Access Compliance Report Public Rights-of-Way (Curb Ramps)

Main Street: AGAPANTHUS_ST		Cross Street: AGAPANTHUS_ST		Location:	N
ADA ID: RPRK211111122725	Ramp Type: Type 4 - Parallel	Initial Pass/Fail: Pass	Overall Compliance: No	Severity Score:	25

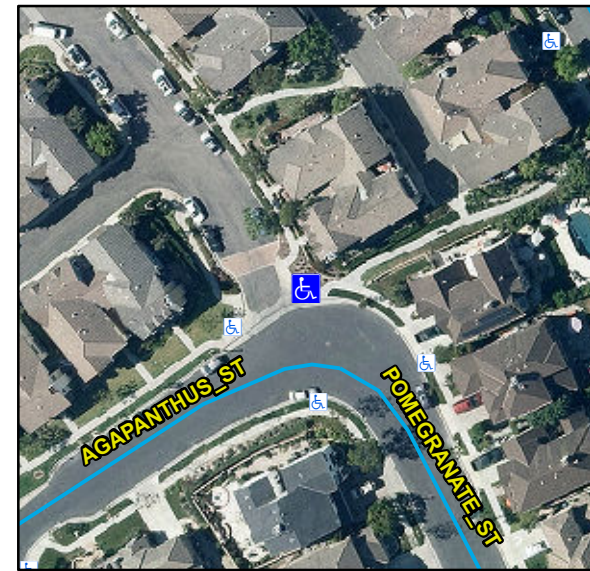
Compliance	Description	Data	Compliance	Description	Data
N/A	Ramp Length LT (in)	133	N/A	Ramp Length RT (in)	134
Yes	Ramp Width LT (in)	54	Yes	Ramp Width RT (in)	54
Yes	Ramp Run Slope LT (%)	4.9	Yes	Ramp Run Slope RT (%)	2.8
Yes	Ramp Cross Slope LT (%)	0.8	Yes	Ramp Cross Slope RT (%)	0.8
N/A	Landing Present	No	No	DWS Provided	No
N/A	Landing Length (in)	N/A	N/A	DWS Contrast	N/A
No	Landing Width (in)	N/A	N/A	DWS Length (in)	N/A
No	Landing Run Slope (%)	N/A	N/A	DWS Full Width	N/A
No	Landing Cross Slope (%)	N/A		DWS Offset Type	N/A
N/A	Landing Movement Obstructed?	No	N/A	DWS Offset Left (in)	N/A
	Landing Movement Type	Curb	N/A	DWS Offset Right (in)	N/A
N/A	Landing Shared	N/A			
N/A	Clear Space	Yes			
N/A	Clear Space To Crosswalk (in)	48			
N/A	Marked Crosswalk 1	No	N/A	Marked Crosswalk 2	No
	Crossing 1 Direction	W		Crossing 2 Direction	SE
	Marked Crosswalk 1 Width (in)	N/A		Marked Crosswalk 2 Width (in)	N/A
N/A	Ramp Inside Crosswalk 1	N/A	N/A	Ramp Inside Crosswalk 2	N/A

Crossing 1 Slope (%)	0		Crossing 2 Slope (%)	1
	Crossing 1 Cross Slope (%)	0.5		Crossing 2 Cross Slope (%)	1.3
Yes	Gutter Ponding	No	No	Curb Slope	9.3
Yes	Gutter Lip Height (in)	0		Road Run Slope (%)	2.3
No	Gutter Run Slope (%)	6.8		Road Cross Slope (%)	5.6
No	Gutter Cross Slope (%)	3.1	No	Perpendicular Joint Present	No
Yes	Overall Surface Condition	Acceptable			
	Cross Gutter Present?	Yes		Spandrel Present?	Yes
	Replace Cross Gutter?	No		Replace Spandrel?	No

Remove & Replace Curb Ramp With Two New Directional Ramps or Equivalent. Remove & Replace Gutter.
